**Economic and Social Council**Distr.: General
22 September 2014

World Forum for Harmonization of Vehicle Regulations**Working Party on Passive Safety****Fifty-sixth session**

**Global technical regulation No. 9 (Pedestrian safety) – Proposal for Phase 2
of the global technical regulation****Draft amendment 2****Submitted by the Informal Working Group on global technical
regulation No. 9***

"Figure 12
Flexible lower legform impactor: Dimensions and centre of gravity locations of femur, knee joint and tibia (side view)

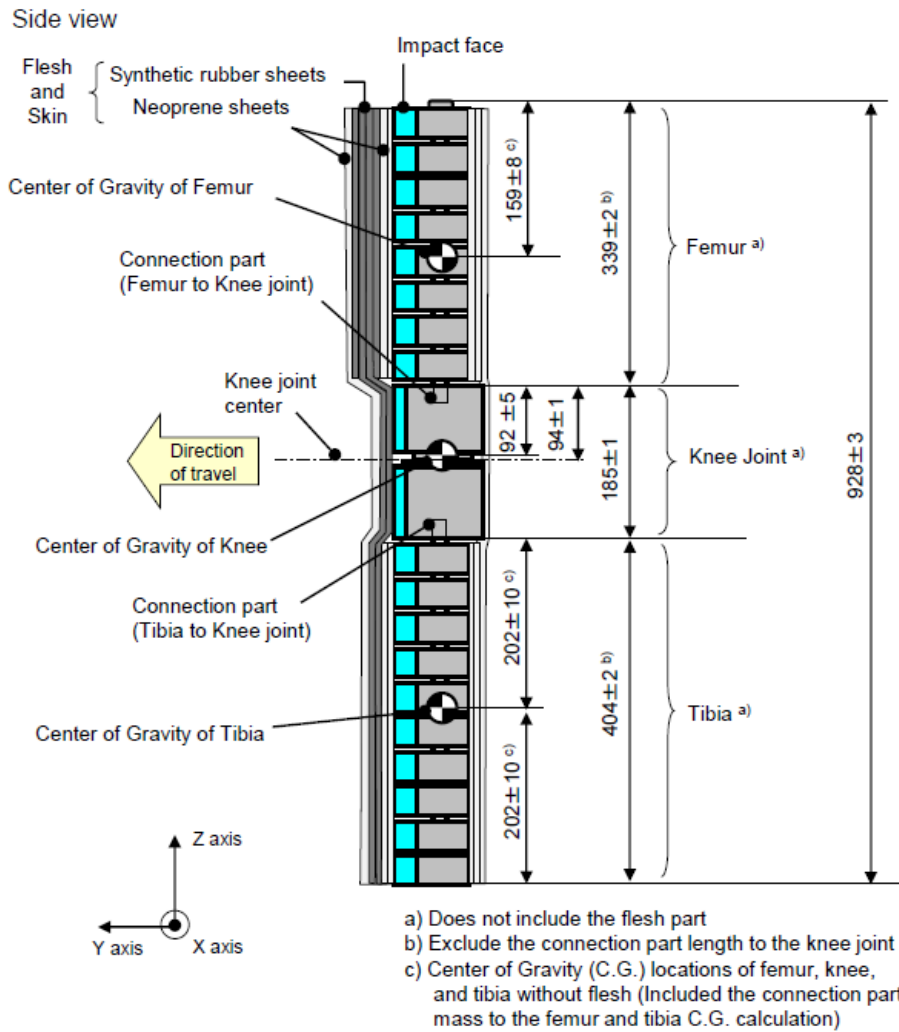
The flexible lower legform impactor shall consist of the flesh and skin, the flexible long bone segments (representing the femur and the tibia), and the knee joint as shown in Figure 12.

~~The lower legform impactor shall consist of two foam covered rigid segments, representing femur (upper leg) and tibia (lower leg), joined by a deformable, simulated knee joint. The overall length of the impactor shall be 926 ± 5 mm, having a required test mass of 13.4 ± 0.2 kg (see Figure 12).~~

The centres of gravity of the femur and tibia without the flesh and skin, including the connection parts to the knee joint, shall be 159 ± 8 mm and 202 ± 10 mm respectively from the top, but not including the connection part to the knee joint, of each part as shown in Figure 12. The centre of gravity of the knee joint shall be 92 ± 5 mm from the top of the knee joint as shown in Figure 12.

Figure 12, shall be deleted:

Figure 13
Flexible lower legform impactor: Schematic plan views of femur, tibia, and knee dimensions (top view)

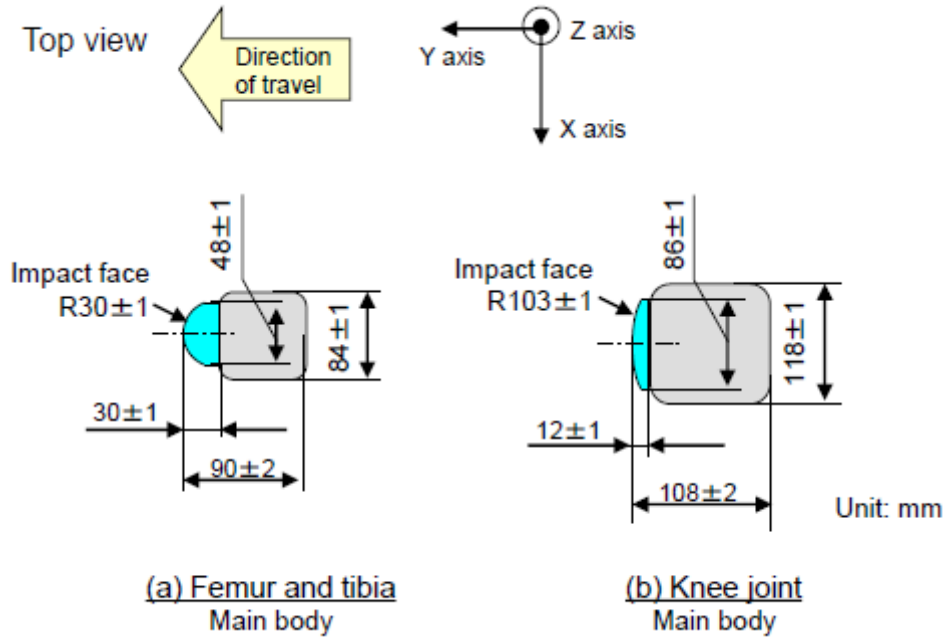
6.3.1.1.1. **The cross-sectional shape perpendicular to the Z-axis of the femur and the tibia main body segments shall be 90 mm in width along the Y-axis, and 84 mm in width along the X-axis as shown in Figure 13 (a). The impact face shall be 30 mm in radius, 30 mm in width along the Y-axis, and 48 mm in width along the X-axis as shown in Figure 13 (a).**

6.3.1.1.2. **The cross-sectional shape perpendicular to the Z-axis of the knee joint shall be 108 mm in width along the Y-axis, and 118 mm in width along the X-axis as shown in Figure 13 (b). The impact face shall be 103 mm in radius, 12 mm in width along the Y-axis, and 86 mm in width along the X-axis as shown in Figure 13 (b).**

Figure 14
Flexible lower legform impactor: Flesh and skin dimensions

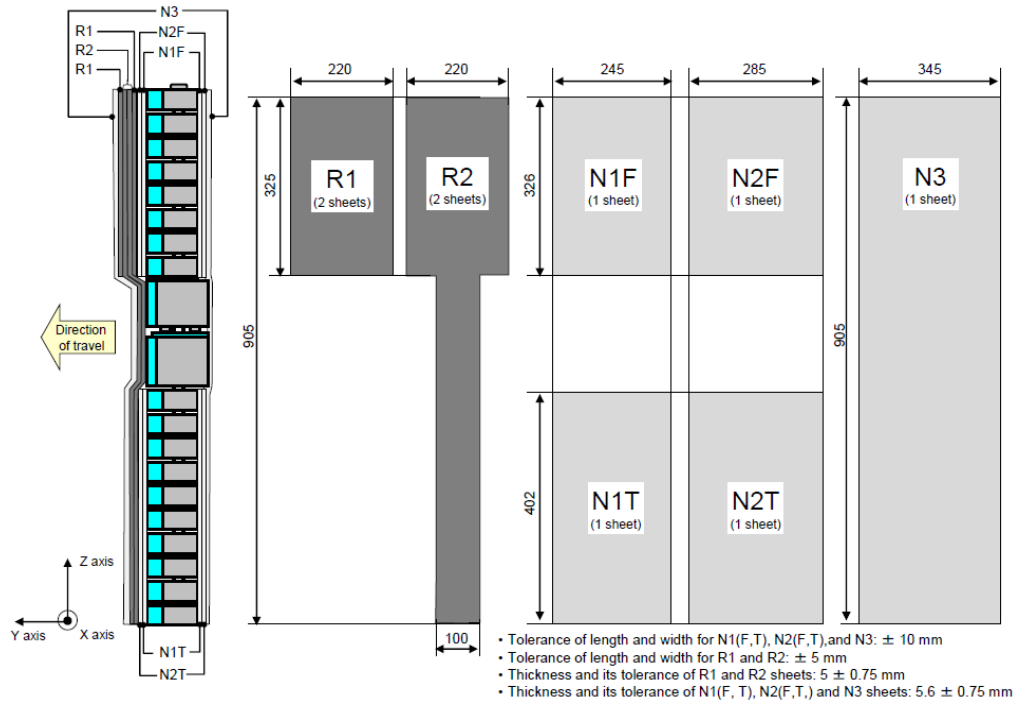
- 6.3.1.1.4. **For each test, the impactor (femur, knee joint and tibia) shall be covered by the flesh and skin composed of synthetic rubber sheets (R1, R2) and neoprene sheets (N1F, N2F, N1T, N2T, N3) as shown in Figure 14. The size of the sheets shall be within the requirements described in Figure 15. The sheets are required to have compression characteristics as shown in Figure 15. The compression characteristics shall be checked using material from the same batch as the sheets used for the impactor flesh and skin.**

Figure 16
Flexible lower legform impactor; Instrument

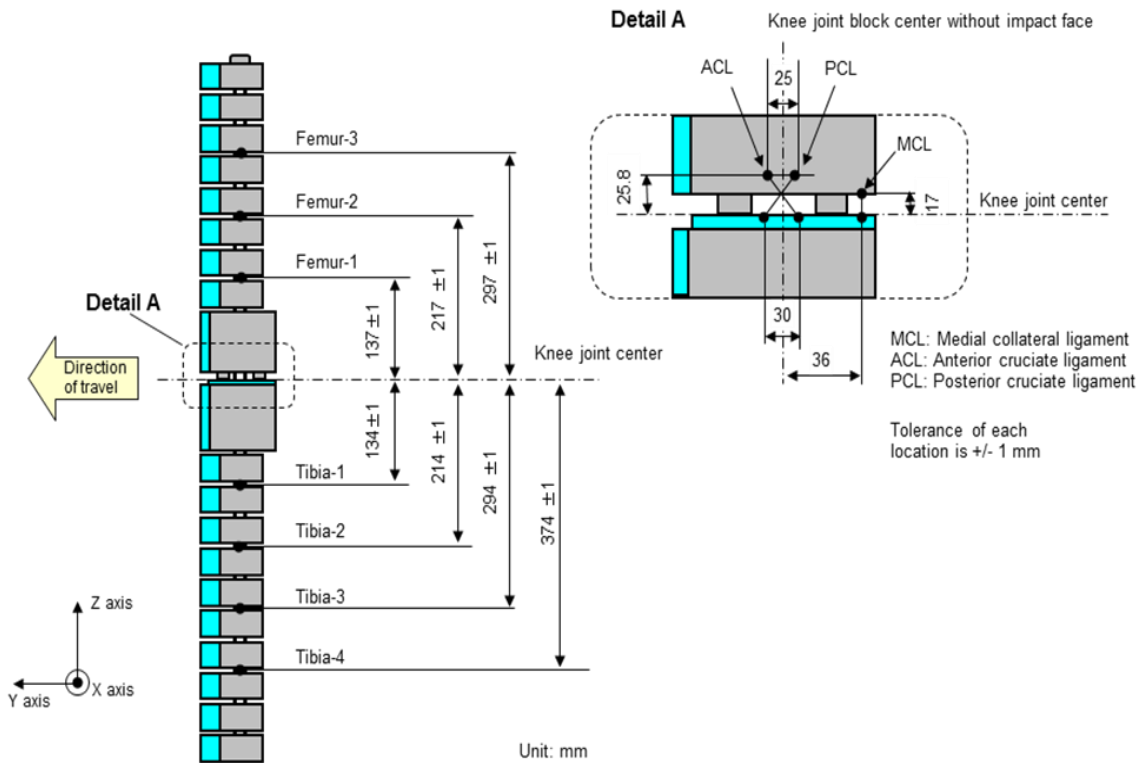
- 6.3.1.1.6.1. **Four transducers shall be installed in the tibia to measure bending moments at locations within the tibia. The sensing locations of each of the transducers are as follows: tibia-1: 134 mm, tibia-2: 214 mm, tibia-3: 294 mm and tibia-4: 374 mm below the knee joint centre respectively as shown in Figure 16.**

Three transducers shall be installed in the femur to measure bending moments applied to the femur. The sensing locations of each of the transducers are as follows: femur-1: 137 mm, femur-2: 217 mm and femur-3: 297 mm above the knee joint centre, respectively, as shown in Figure 16.

"Figure 20

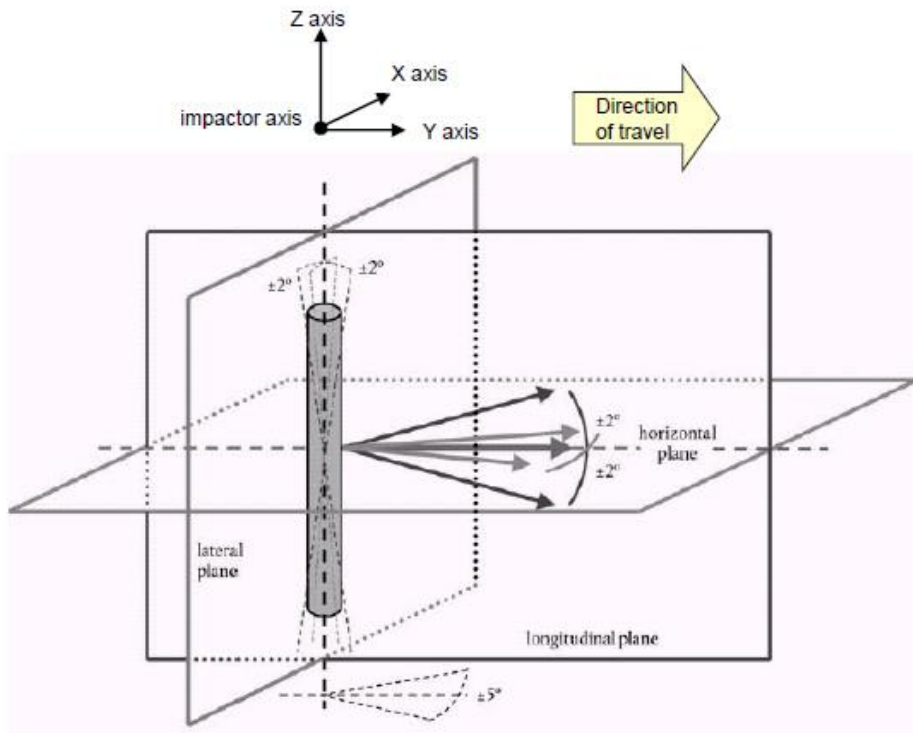
7.1.1.2. **The direction of the impact velocity vector shall be in the horizontal plane and parallel to the longitudinal vertical plane of the vehicle. The tolerance for the direction of the velocity vector in the horizontal plane and in the longitudinal plane shall be $\pm 2^\circ$ at the time of first contact. The axis of the impactor shall be perpendicular to the horizontal plane, with a roll and pitch angle tolerance of $\pm 2^\circ$ in the lateral and longitudinal plane. The horizontal, longitudinal and lateral planes are orthogonal to each other (see Figure 20).**

7.1.1.3.2. **At the time of first contact the impactor shall have the intended orientation about its vertical axis, for the correct operation of its knee joint, with a yaw angle tolerance of $\pm 5^\circ$ (see Figure 20).**

Figure 21

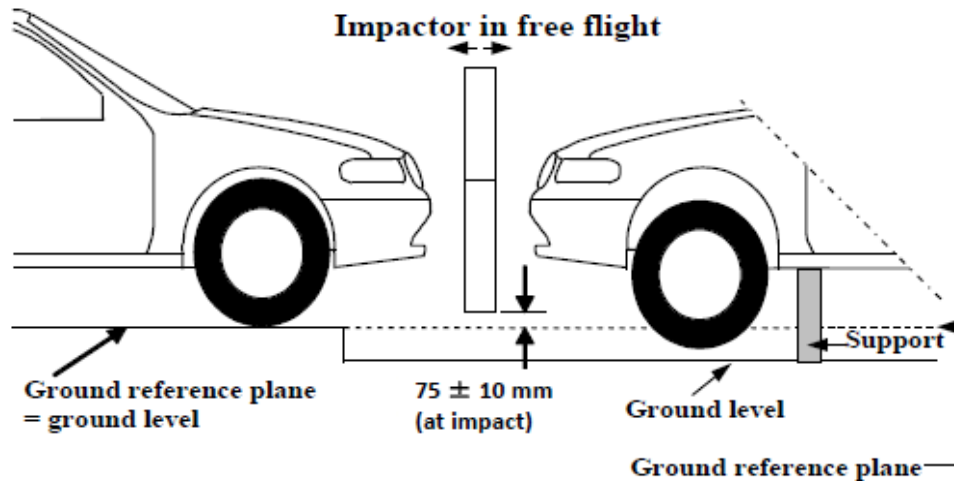
7.1.1.3. **The bottom of the impactor (without parts needed for the purposes of launching and/or protection) shall be 75 mm above the ground reference plane at the time of the first contact with the bumper (see Figure 21), with a tolerance of ± 10 mm. When setting the height of the propulsion system, an allowance must be made for the influence of gravity during the period of free flight of the impactor.**

Figure 22

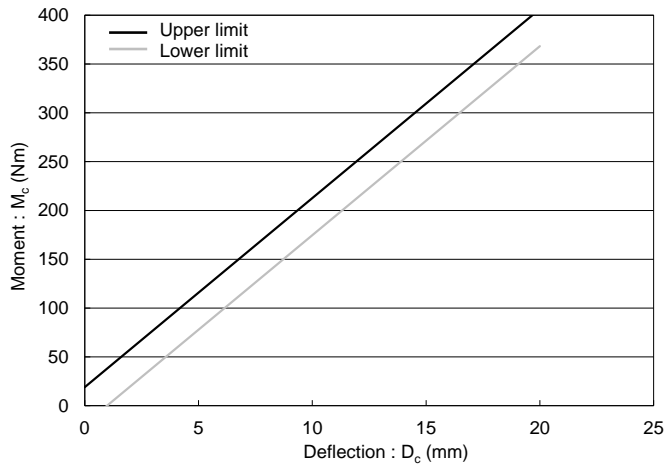
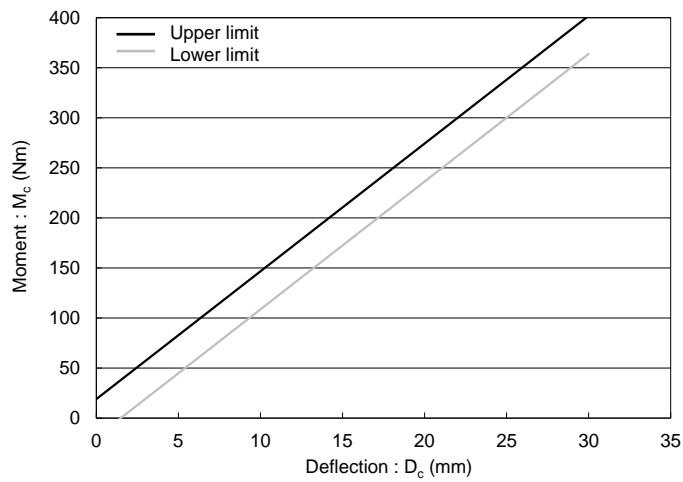
- 8.1.1.2. **When the femur and the tibia of the impactor are loaded in bending in accordance with paragraph 8.1.1.4., the applied moment and the generated deflection at the centre of the femur and the tibia (M_c and D_c) shall be within the corridors shown in Figure 22.**

Figure 23
Flexible lower legform impactor: Requirement corridors for the knee joint in the static certification test (see paragraph 8.1.1.3.)

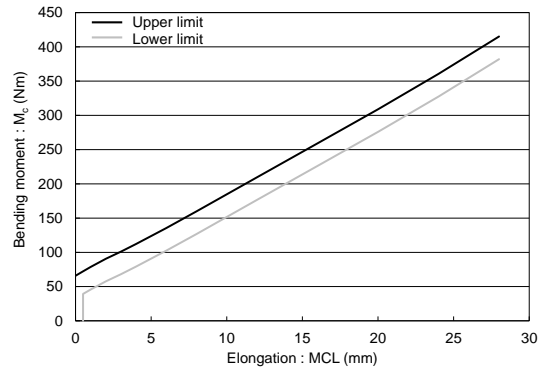
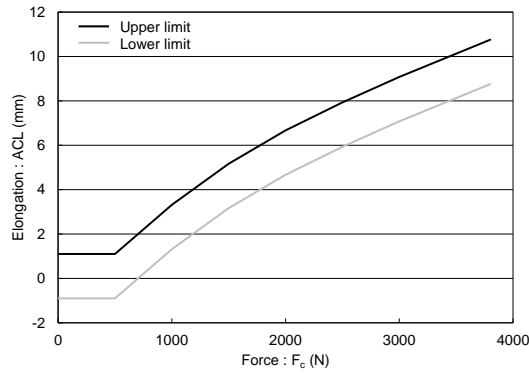
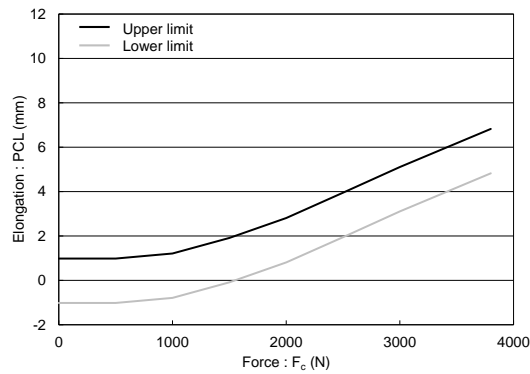
- 8.1.1.3. **When the knee joint of the impactor is loaded in bending in accordance with paragraph 8.1.1.5., the MCL, ACL, and PCL elongations and applied bending moment or the force at the centre of the knee joint (M_c or F_c) shall be within the corridors shown in Figure 23.**

Figure 24
Flexible lower legform: Impactor test set-up for the femur in the static certification test (see paragraph 8.1.1.4.)

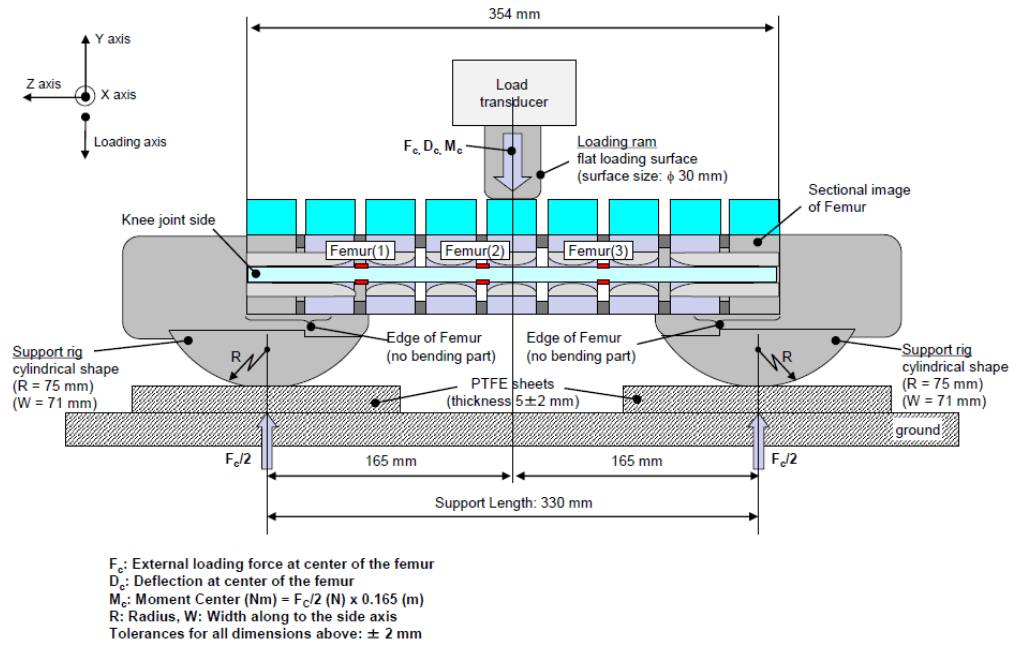
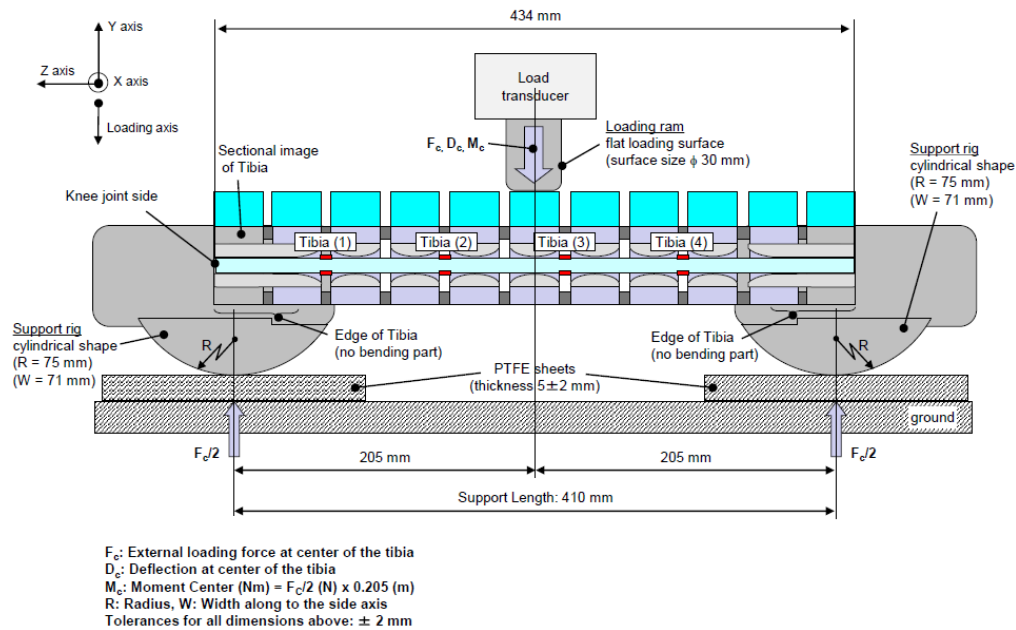
- 8.1.1.4. **The edges of the femur and tibia, not bending parts, shall be mounted to the support rig firmly as shown in Figure 24 and Figure 25. The Y-axis of the impactor shall be parallel to the loading axis within $180 \pm 2^\circ$ tolerance. To obtain repeatable loading, low friction Polytetrafluoroethylene (PTFE) plastic pads are used under each support (see Figures 24 and 25).**

Figure 26
Flexible lower legform impactor: Test set-up for the knee joint in the static certification test (see paragraph 8.1.1.5.)

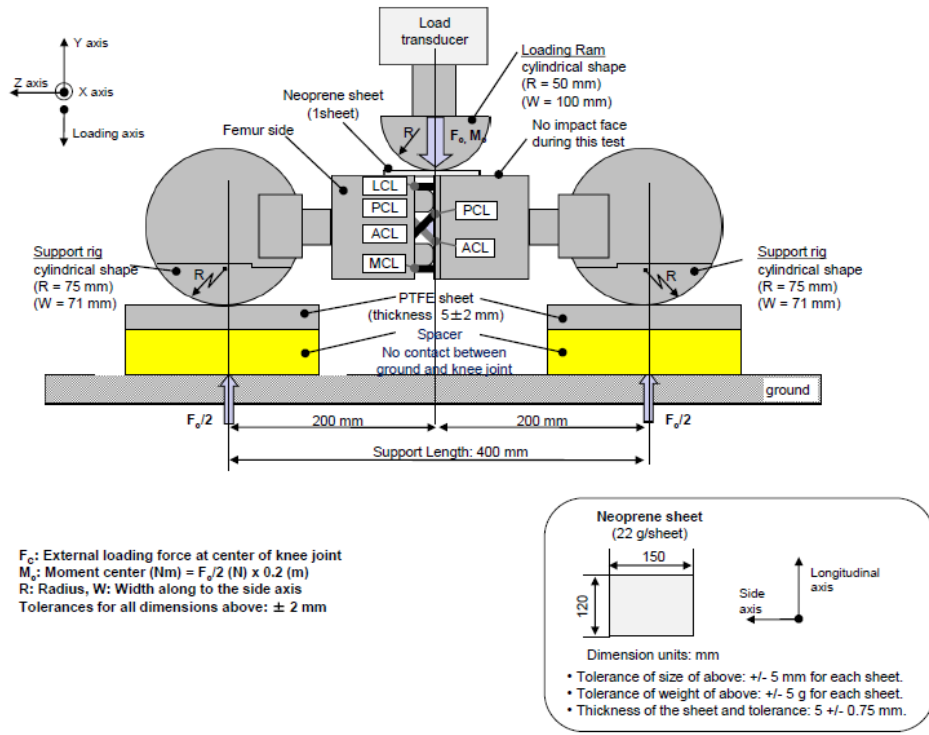
- 8.1.1.5. **The ends of the knee joint shall be mounted to the support rig firmly as shown in Figure 26. The Y-axis of the impactor shall be parallel to the loading axis within ± 2° tolerance. To obtain repeatable loading, low friction Polytetrafluoroethylene (PTFE) plastic pads are used under each support (see figure 26). To avoid impactor damage, a neoprene sheet shall be set underneath the loading ram and the impactor face of the knee joint which is described in the Figure 13 shall be removed. The neoprene sheet used in this test shall have compression characteristics as shown in Figure 15.**

Figure 27
Flexible lower legform impactor: Test set-up for the dynamic lower legform impactor certification test (pendulum test, see paragraph 8.1.2.4.)

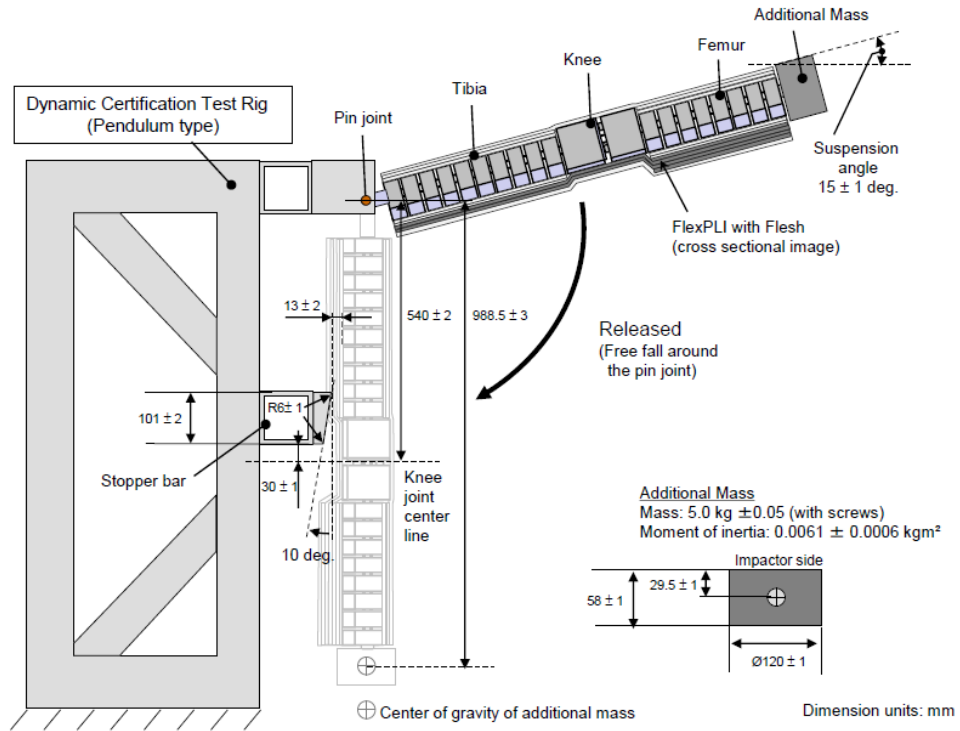
- 8.1.2.4.1. **The flexible lower legform impactor, including the flesh and skin, shall be suspended from the dynamic certification test rig $15 \pm 1^\circ$ upward from the horizontal as shown in Figure 27. The impactor shall be released from the suspended position and fall freely against the pin joint of the test rig as shown in Figure 27.**

- 8.1.2.4.2. **The knee joint centre of the impactor shall be 30 ± 1 mm below the bottom line of the stopper bar, and the tibia impact face without the flesh and skin shall be located 13 ± 2 mm from the front upper edge of the stopper bar when the impactor is hanging freely as shown in Figure 27.**

Figure 28
Flexible lower legform impactor: Test set-up for the dynamic lower legform impactor certification test (inverse test, see paragraph 8.1.3.4.)

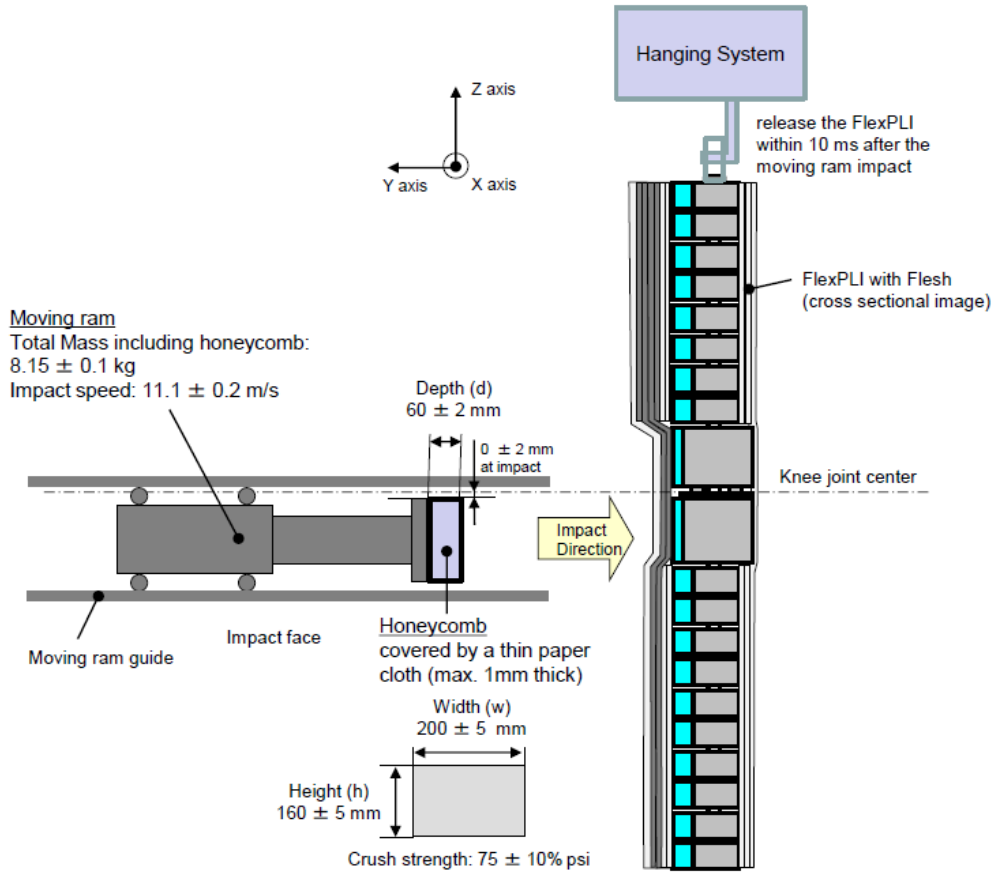
- 8.1.3.4. Test procedure
- 8.1.3.4.1. The assembled flexible lower legform impactor (with the flesh and skin) shall be hung vertically and freely suspended from a test rig as shown in Figure 28. It is then impacted by the upper edge of a linearly guided aluminium honeycomb impactor, covered by a thin paper cloth with a maximum thickness of 1 mm, at an impact speed of 11.1 ± 0.2 m/s. The legform shall achieve a free flight condition within 10 ms after the time of first contact of the honeycomb impactor.
